D827 MCH

Software up-date V 2.0

SI 161 a/95**D827 MCH Software up-date V 2.0****Contents:**

1.863.655.20 Central Processor unit CPU with
1.862.683.20 CPU piggy back

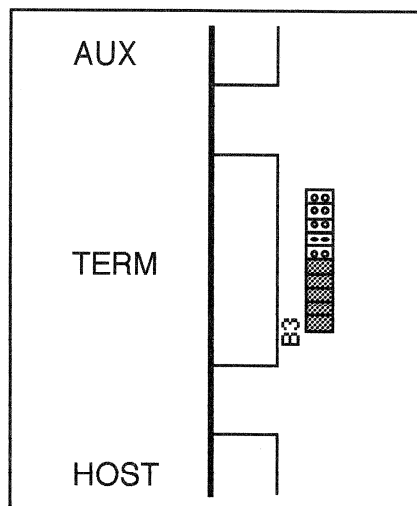
New CPU Software V 2.0 (05/95)

- Replace **IC 3 to 6** (old software number 1.863.926.20) by new software (05/95) **1.863.926.21**
- Change Index on the CPU Piggy Back to new 1.863.683.21
- Change on the grip the index of the CPU board to new 1.863.655.21
- Clear the RAM (IC 7 and 8 on CIF, 1.863.654.21), by removing it from its socket and short circuiting it on a metal surface.

- Modify the Jumper Array B3 (behind the TERM socket) as followed:

- Remove two jumpers and the wrap wire according to the drawing
- Add on jumper according to the drawing.

Result: 5 Jumpers left are inserted in B3
